The attention of bidders submitting proposals for the subject project noted above is called to the following Addendum to the Contract Forms and Specifications.

This Addendum consists of the following information:

TWIN TOWERS
MIDDLE SCHOOL

ENLARGED CITY SCHOOL
DISTRICT OF MIDDLETOWN

1 PLUMBING - FIRST FLOOR PLAN - AREA S
1/8" = 1'-0"

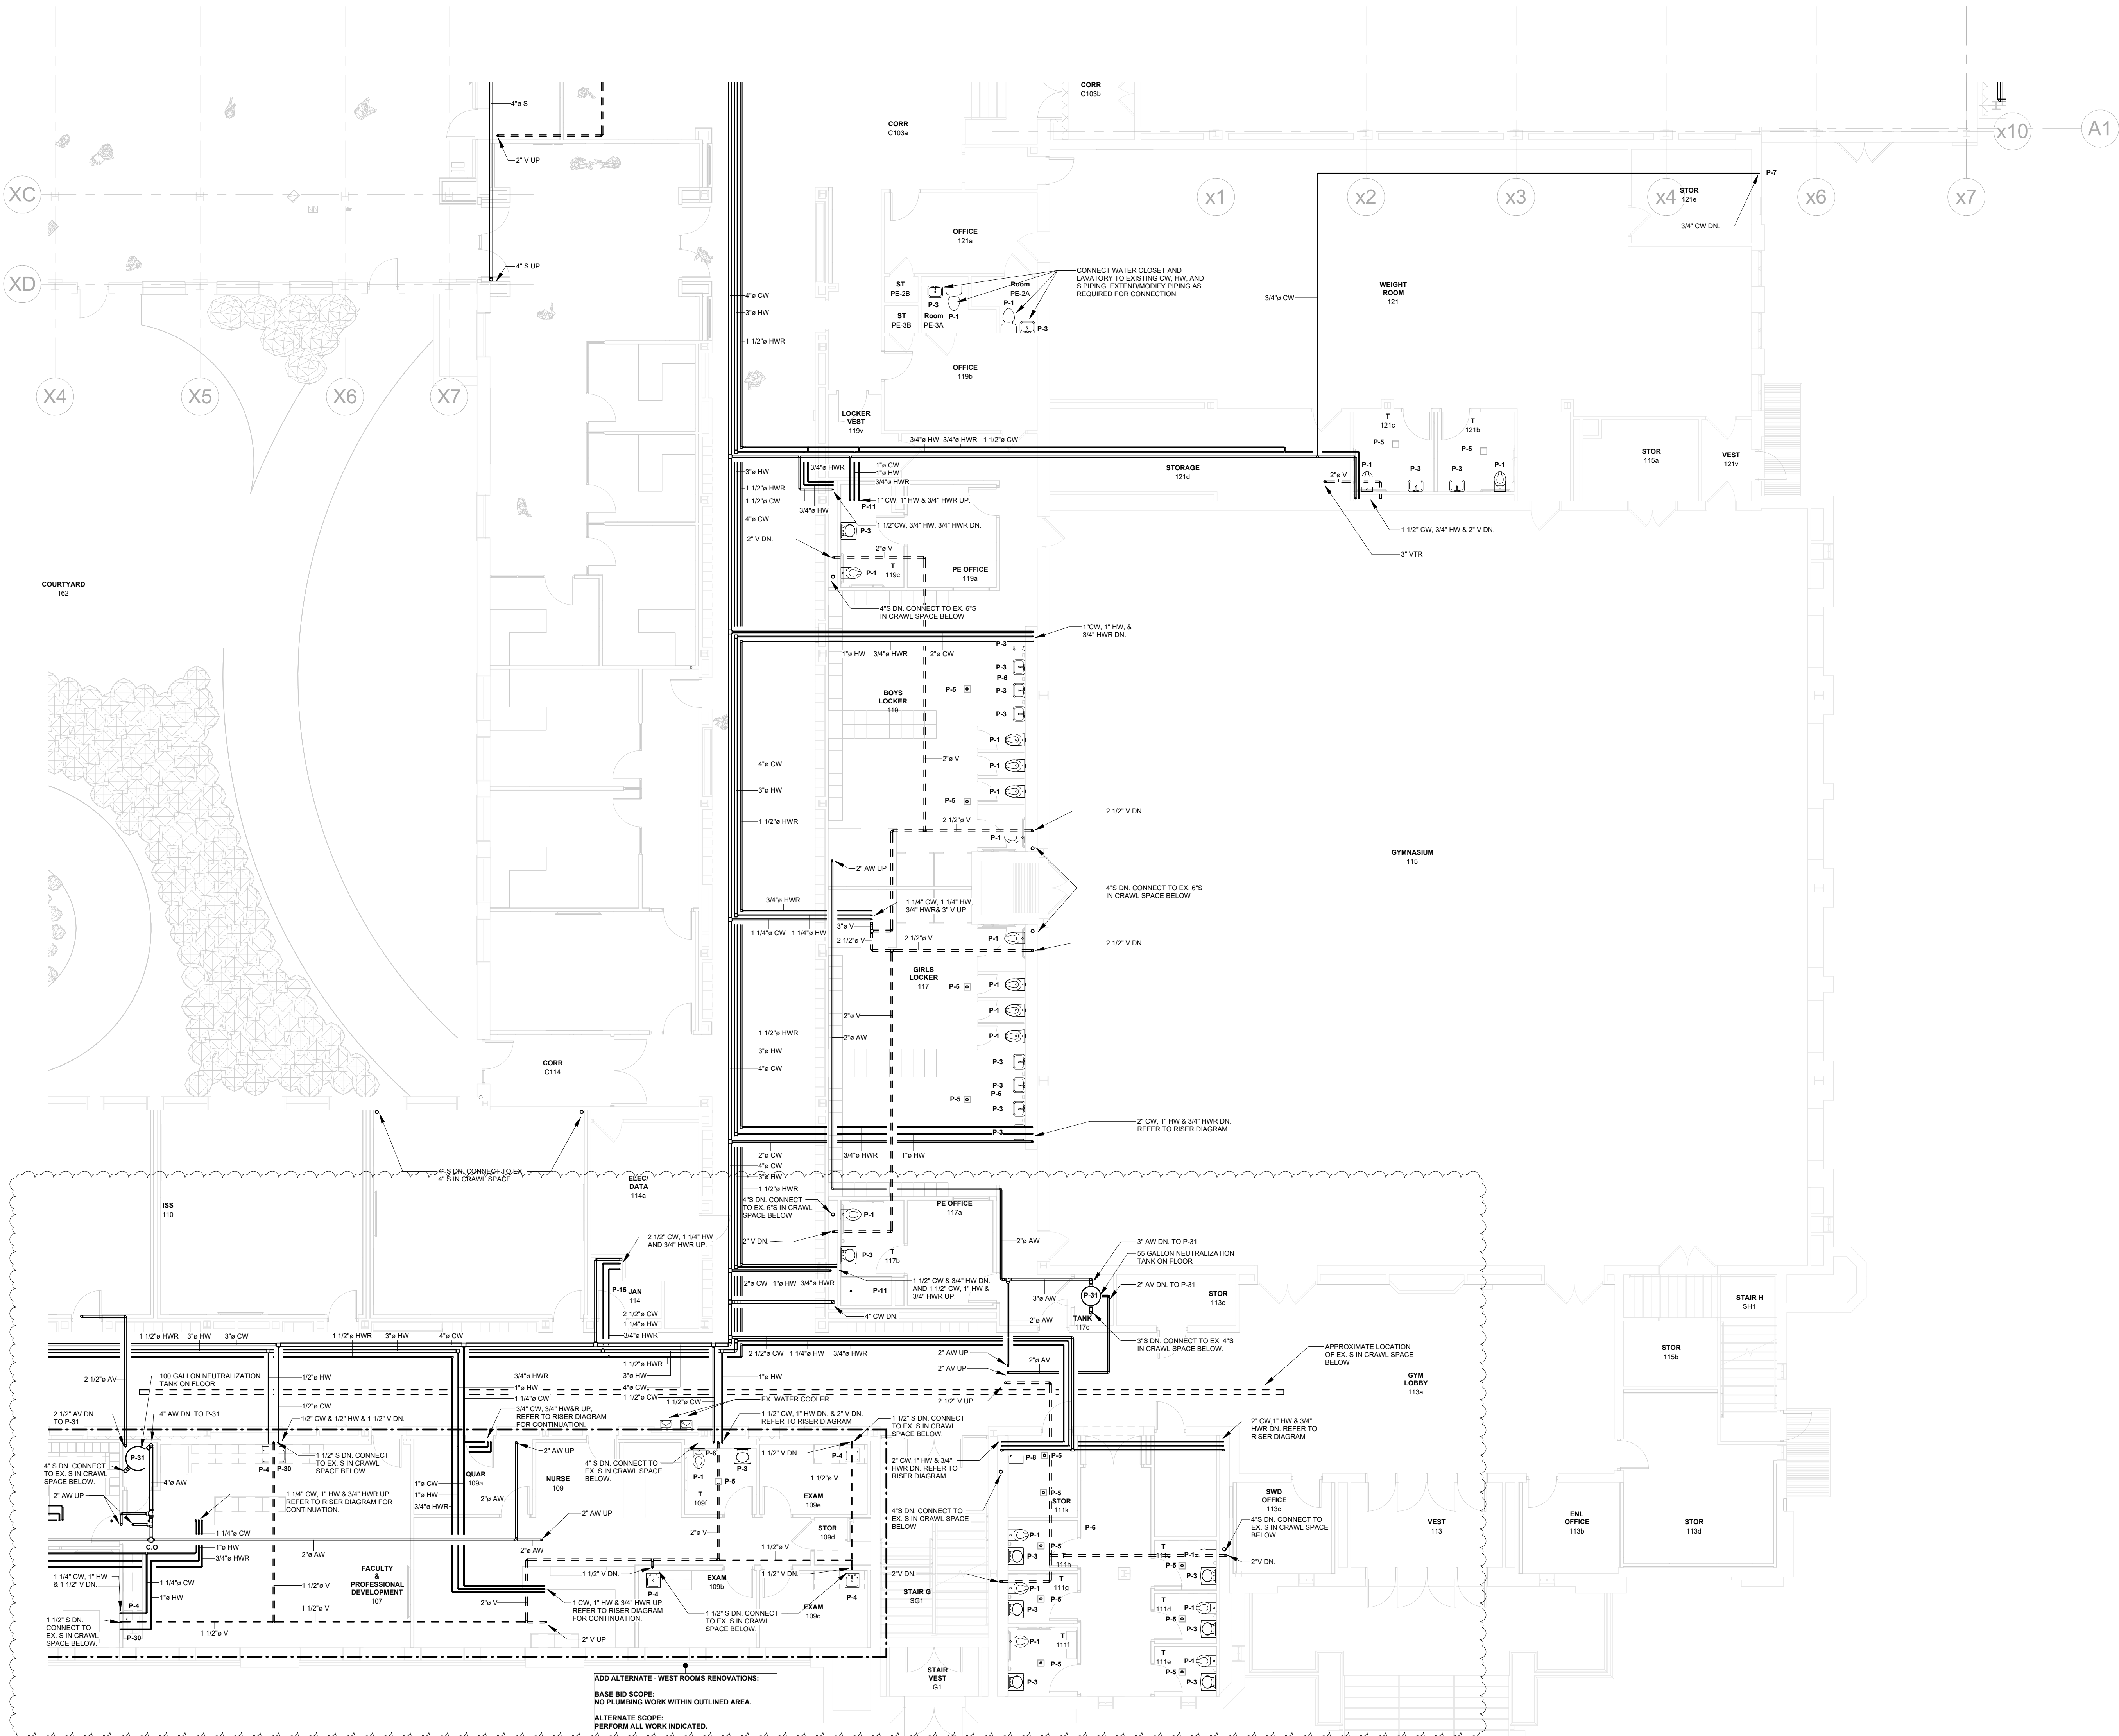
- 4) Drawing P201.N – REVISE drawing to clarify pipe drop locations. Refer to revised drawing included with addendum.
- 5) Drawing P201.S – REVISE drawing to clarify pipe drop locations. Refer to revised drawing included with addendum.
- 6) Drawing P202.NS – REVISE drawing to clarify pipe drop locations. Refer to revised drawing included with addendum.
- 7) Drawing P203.NS – REVISE drawing to clarify pipe drop locations. Refer to revised drawing included with addendum.
- 8) Drawing P701 – ADD floor mounted water closet. Refer to revised drawing included with addendum.
